<b>City of Rocky Mount Addendum 1</b>		
	<b>Refer <u>ALL</u> Inquiries regarding this RFP to:</b> Chynice Chapman Purchasing Manager	<b>RFLOI # 320-050222CC Pedestrian Signals EB-5711</b>	
		<b>RFLOI Due Date: 03/25/2022</b>	
	<b>Contract Type: A&amp;E</b>

RFLOI PED SIGNALS  
EB-5711  
CITY OF ROCKY MOUNT  
NASH COUNTY NORTH CAROLINA

SHEET TITLE:  
VISUAL FOR  
RFLOI

#4 GRACE ST & SUNSET AVE

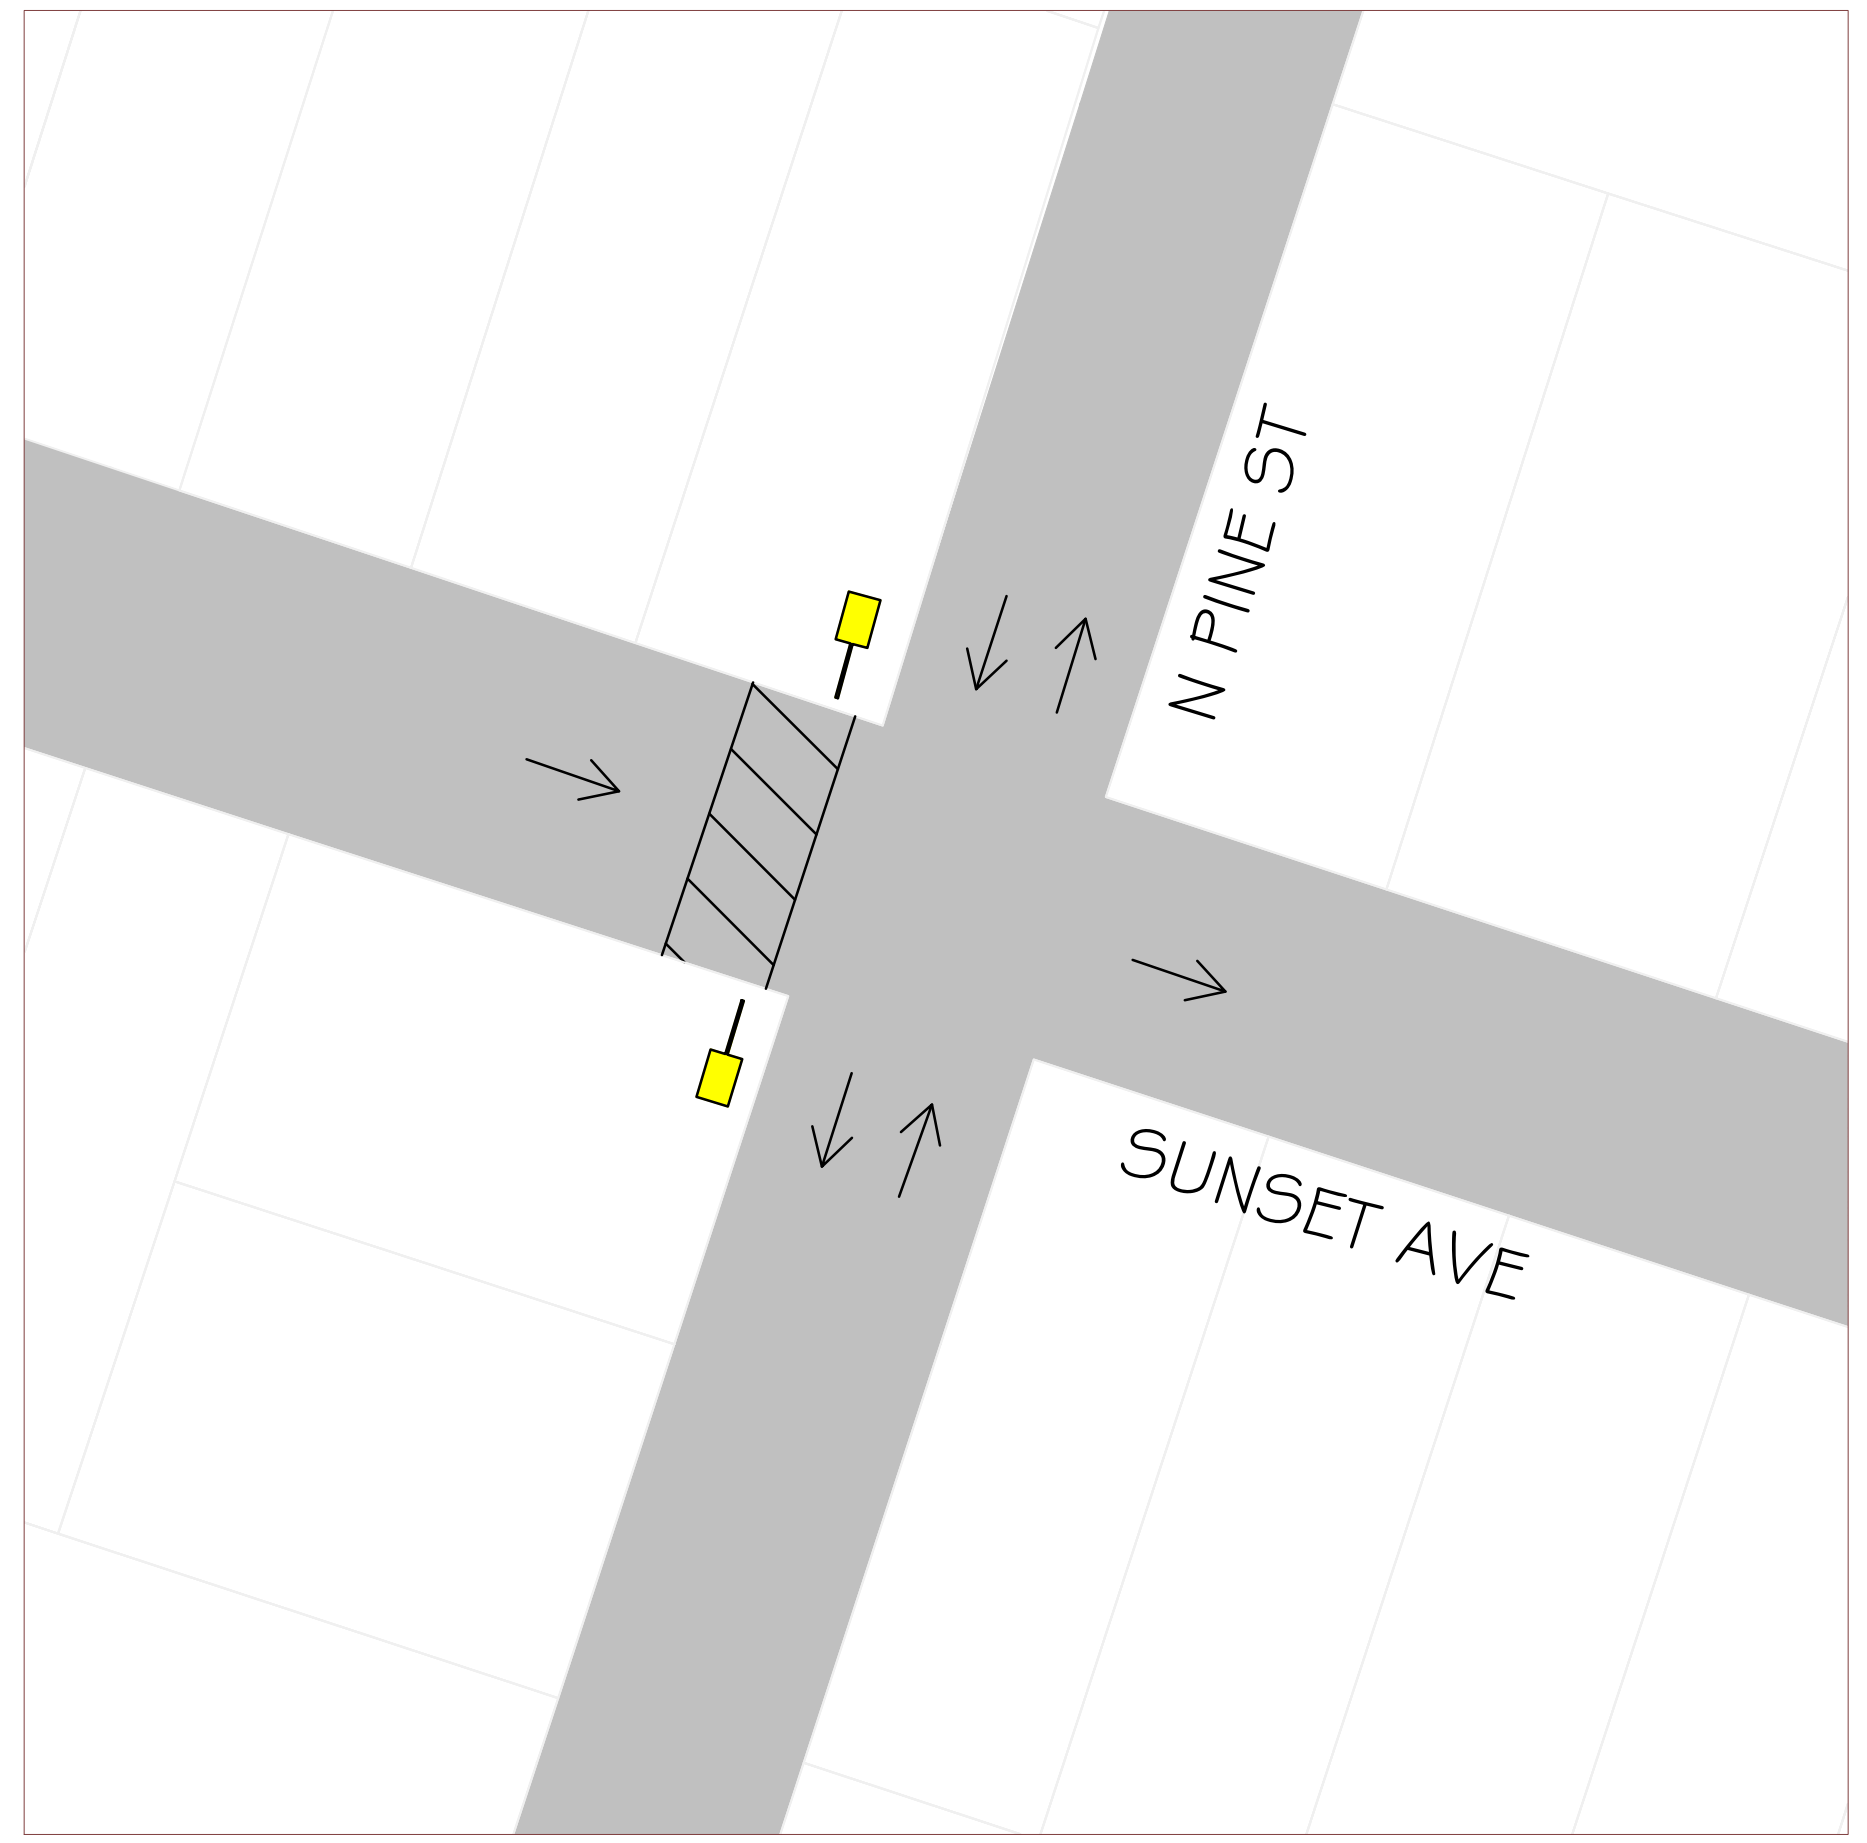
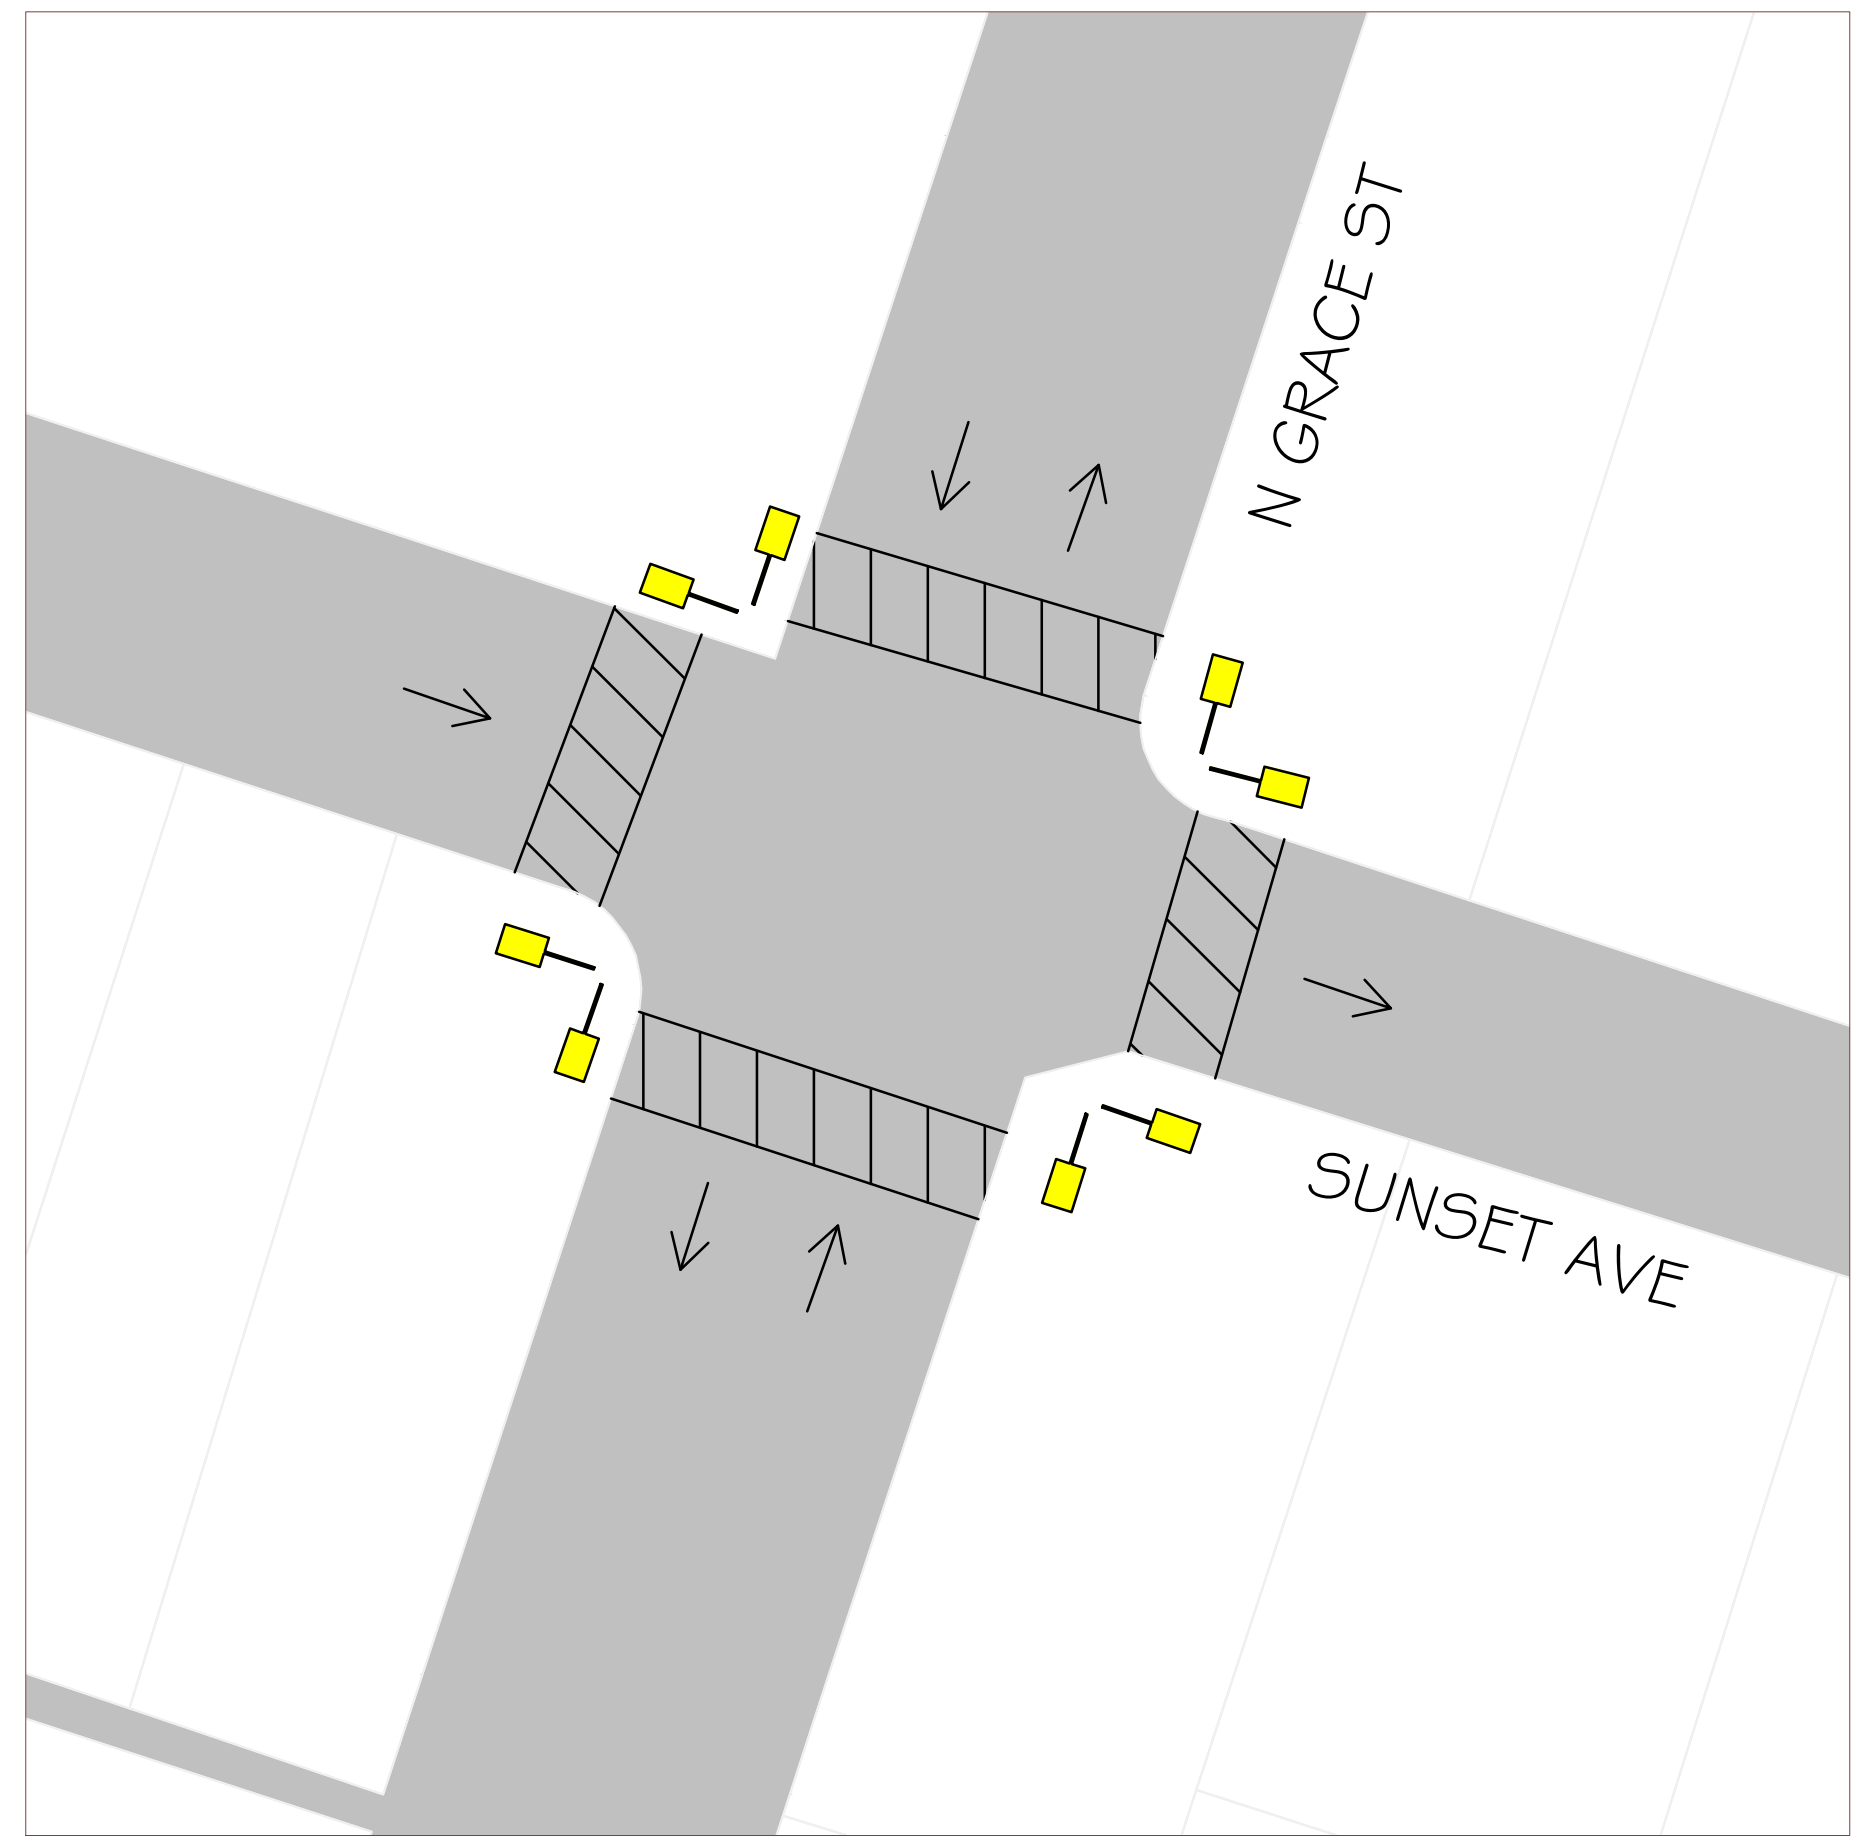
2. **Question:** Are only existing crosswalks to be signalized or does the city anticipate adding new crosswalks to be signalized as part of this project?

Lee street and Pine Street only require one cross walk and pedestrian signal over Sunset Avenue. May Drive, Grace Street, and Franklin Street require crosswalks and pedestrian signals at all four legs of the intersections. See attached sketch for more details.

1. MAY DR: 4 CROSSWALKS, 4 PED SIGNAL PAIRS
2. LEE ST: 1 CROSSWALK, 1 PED SIGNAL PAIR
3. PINE ST: 1 CROSSWALK, 1 PED SIGNAL PAIR
4. GRACE ST: 4 CROSSWALKS, 4 PED SIGNAL PAIRS
5. FRANKLIN ST: 4 CROSSWALKS, 4 PED SIGNAL PAIRS
